MM-2001 PINSETTER

Fenix Service Bulletin Number MM-001

**Carousel Staging Modification.***May 1999*

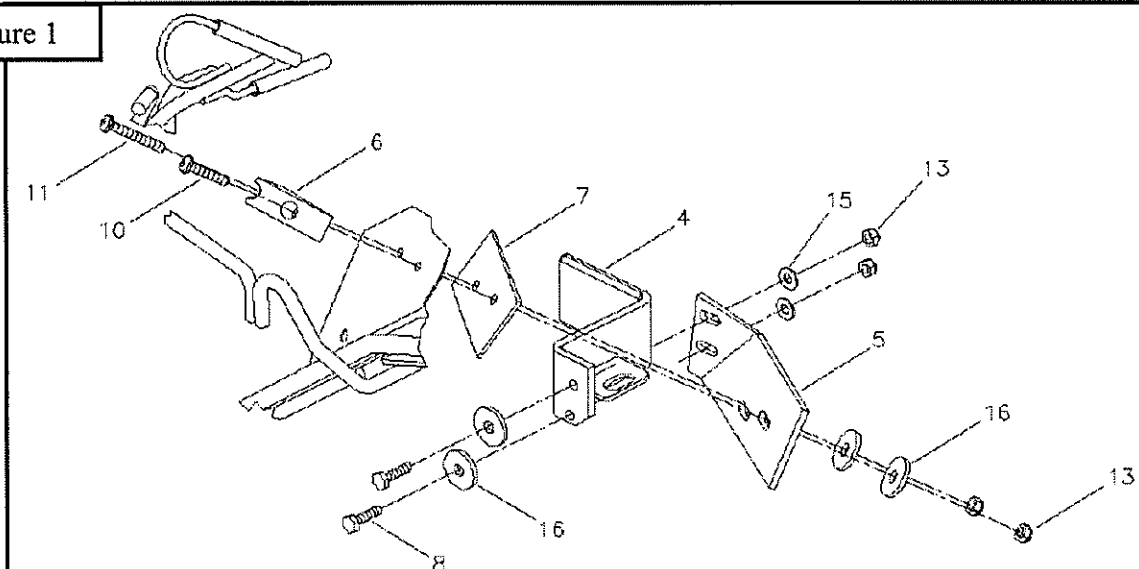
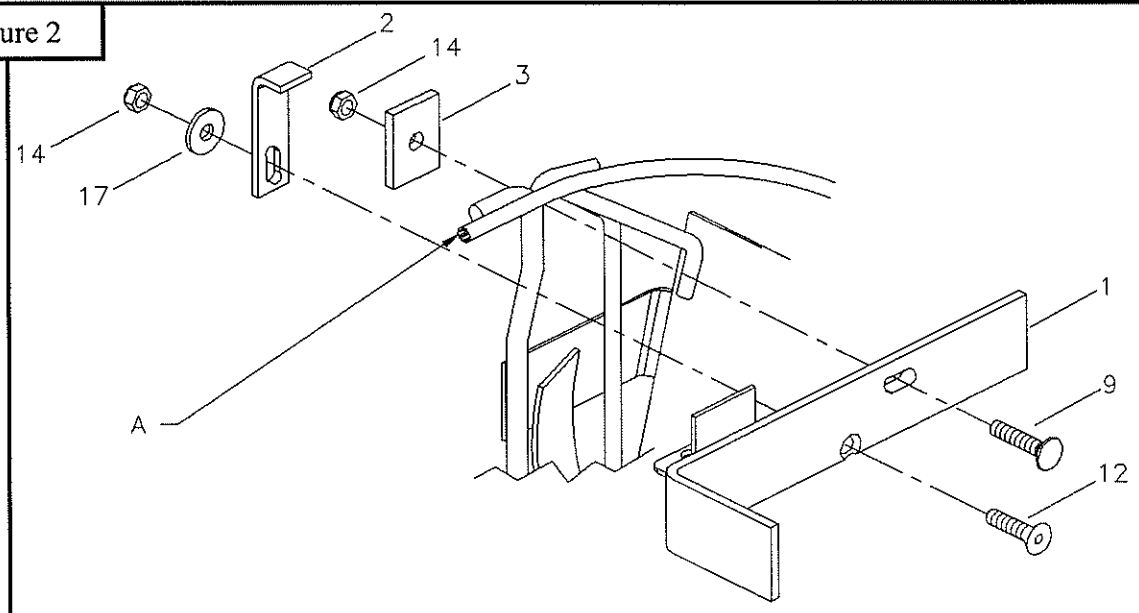
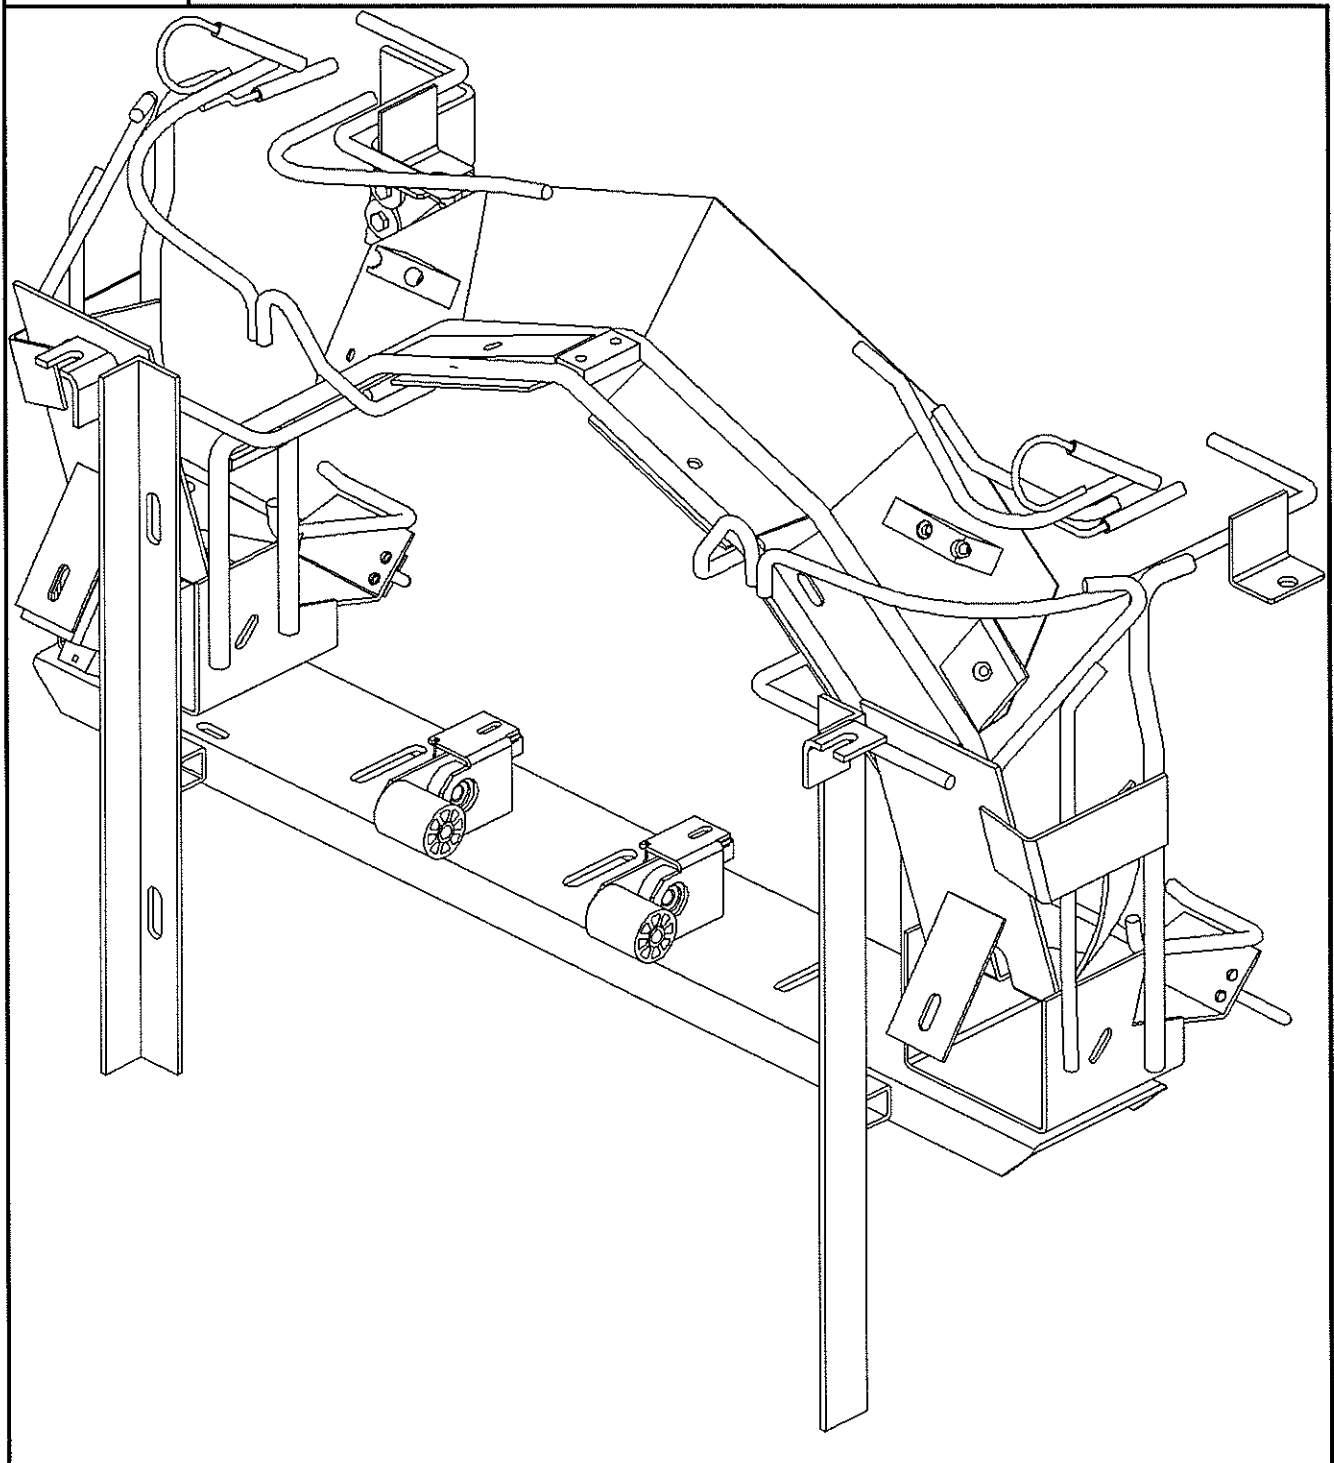
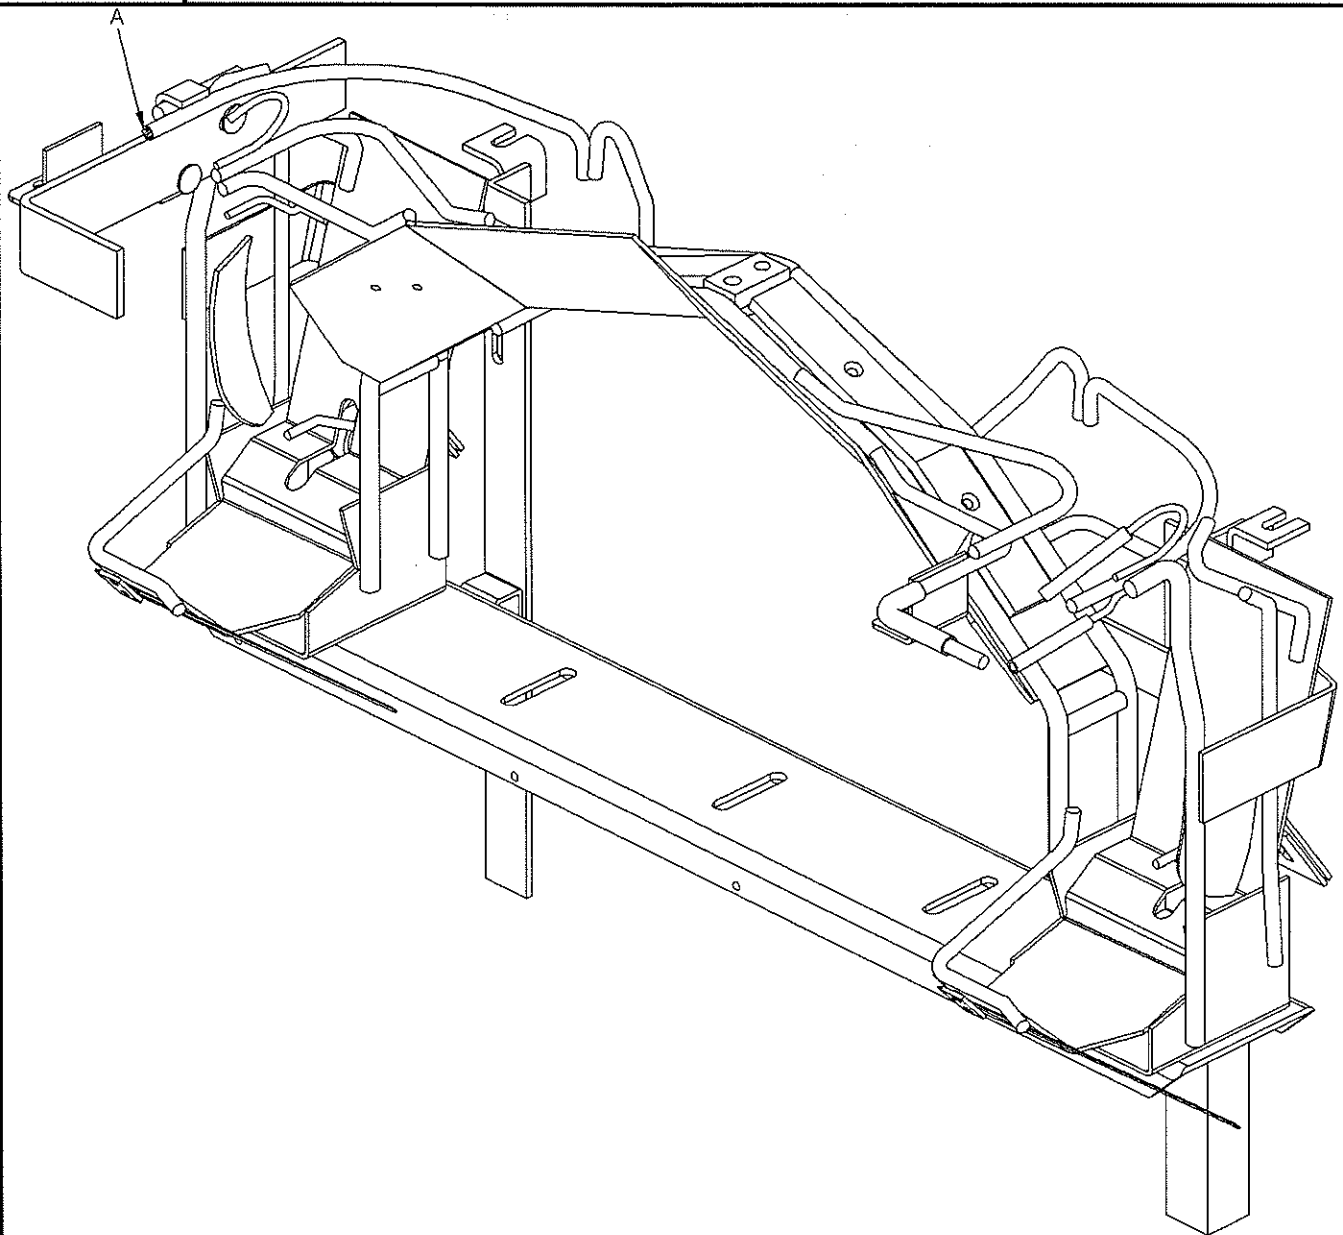
Starting with MM-2001 pinsetter serial number MMP-_____, two new reinforcements were added to the « Carousel Staging » (302-8500-00).

This measure was implemented in order to prevent the breaking of the « Carousel Staging » (302-8500-00). Please take note that this modification is possible even if the « Carousel Staging » (302-8500-00) is not damaged.

Installation Procedure:**A- Left Reinforcement : (Figure 2 & Figure 4)**

- 1- Bolt together the following parts: 302-8510-00, 302-8520-00 and 302-8530-00. For the "carriage bolt" (7012-003716-150), please take note that it should pass between the two rods of the "Carousel Staging".
(Figure 2 & 4)
- 2- To finalize the adjustment of the part "staging frame brace" (302-8510-00), it is necessary to move it (up / down & front / back) in order to have the head of the pin supported by the rod and the "staging frame brace" (302-8510-00) at the same time.

**B- Right Reinforcement : (Figure 1 & Figure 3)**

- 1- Remove the "Slide Guide, Top" (303-8510-00).
- 2- Re-install the "Slide Guide Top" (303-8510-00) with the "Shim Absorber" (304-8545-00) and the "Staging Frame Brace" (302-8545-00). (Figure 1 & 2)
- 3- Install the "Staging Frame Brace" (302-8540-00) on the "Staging frame Brace" (302-8545-00).
- 3- To finalise the adjustment of part two staging frame brace (302-8540-00 & 302-8545-00), it will be necessary to move it (up / down & front / back) in order to have the head of the pin supported by the rod and the "staging frame brace" (302-8540-00) at the same time.
